Our Ref: MX.R1

15 February 2016

**PROPOSED SAND QUARRY, CABBAGE TREE ROAD, WILLIAMTOWN –
REVIEW OF EIS GROUNDWATER STUDIES**

Figure 4 - Williamstown RAAF Contamination Investigation Area

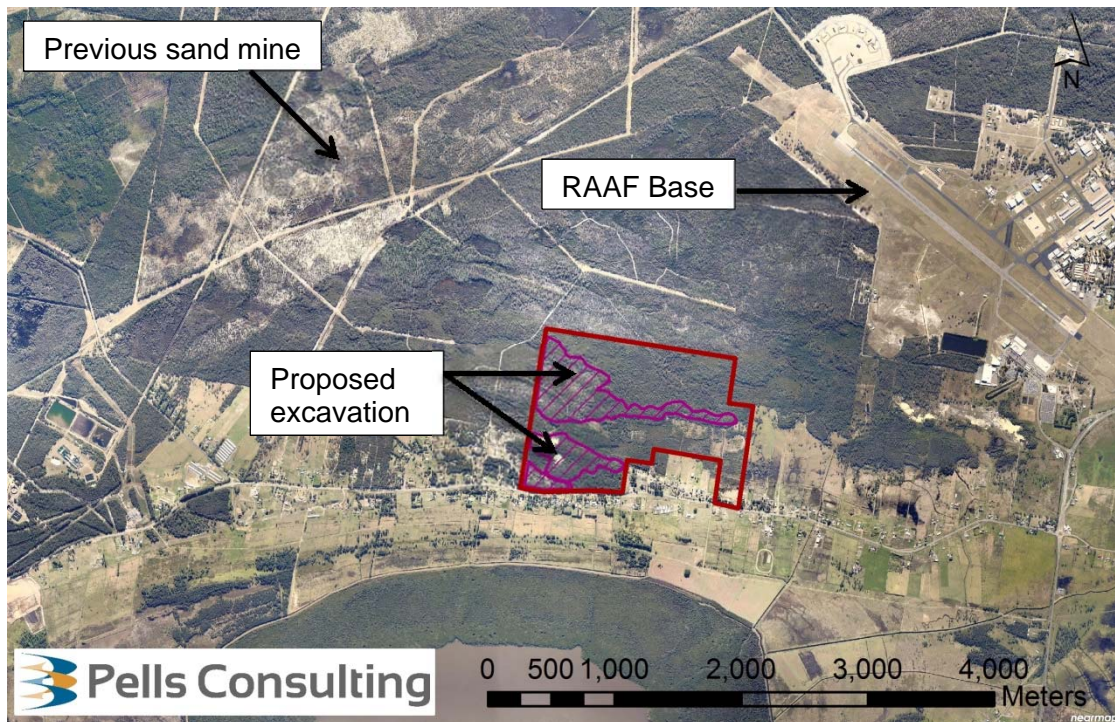
As the groundwater flow is toward the ocean, it is perceived that there is potentially limited affect from the Williamstown RAAF contamination. Nonetheless, the proposed mine is within the formal examination area, and the potential interactions with this contamination source and current contamination studies should be considered.

Figure 6 - Proposed final mining landform

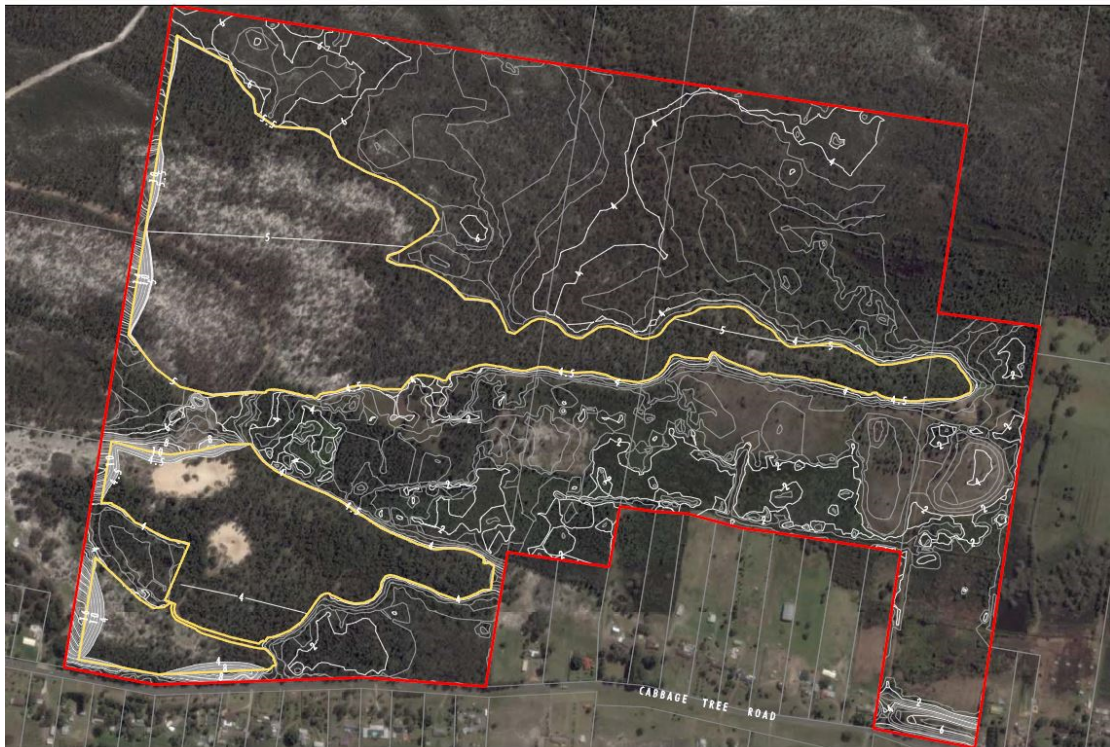
These changes to recharge may result in local increases to groundwater levels at the mine site. Such raises in groundwater levels could potentially in inundation of the currently proposed mining plan, and groundwater levels would thus need to be drawn down, by pumping, to allow the current mining plan to be undertaken. The impacts of such pumping, and planned disposal of groundwater, is not addressed in the EIS.

The groundwater studies should be revised to consider changes to recharge and evapotranspiration in assessing design groundwater levels. The mining layout should therefore be revised accordingly.

If the mining plan is not revised, the EIS must incorporate an environmentally-appropriate plan of action for dealing with elevated groundwater levels.

Figure 8 - Highest recorded groundwater levels (Umwelt, 2015)

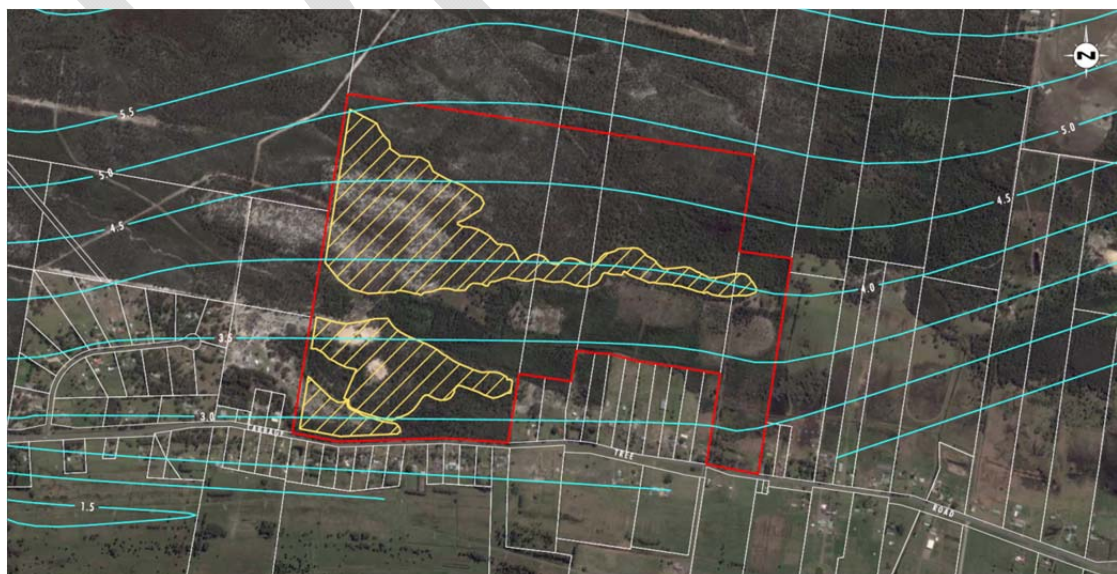
It is also unclear why the maximum predicted groundwater levels adopted in the EIS (Figure 12) are lower than highest recorded groundwater levels (Figure 8).

Figure 12 - Maximum predicted recorded groundwater levels (Umwelt, 2015)

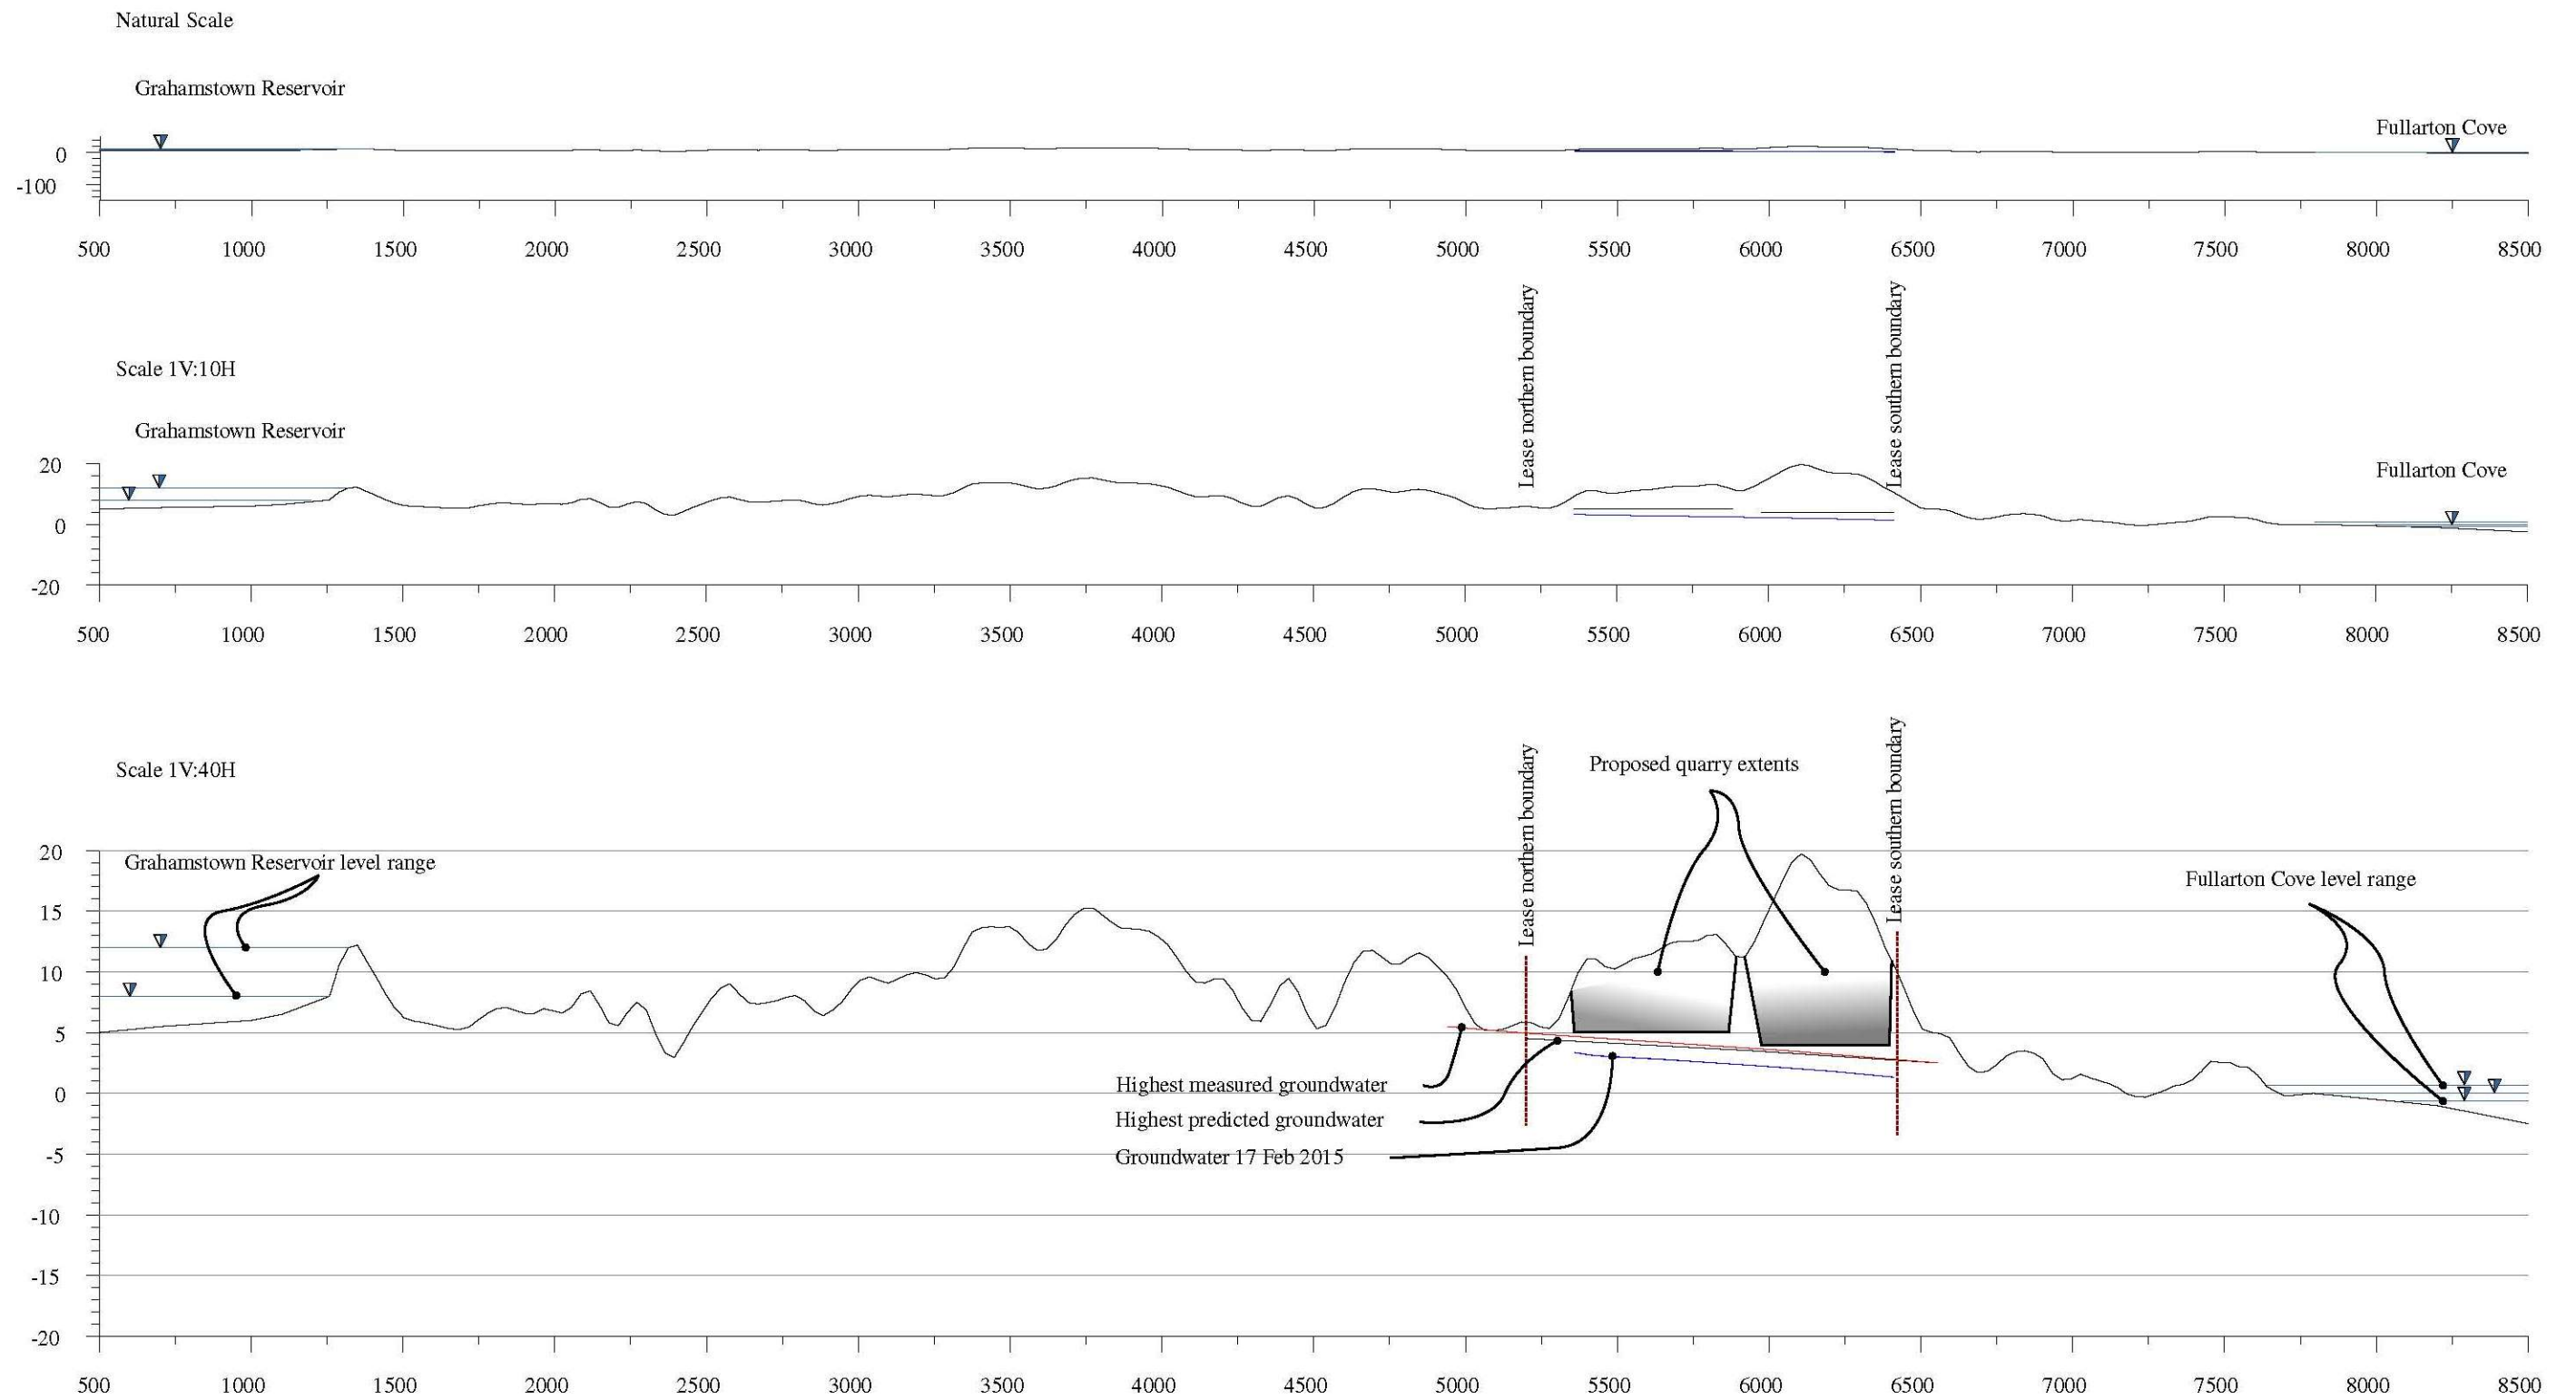
The formal groundwater levels adopted in the EIS are understood to be based on modelling undertaken by Umwelt (2015), as presented in Appendix 7 of the EIS. The predicted maximum level used for planning is reproduced in Figure 12. No prediction of average groundwater levels is shown.
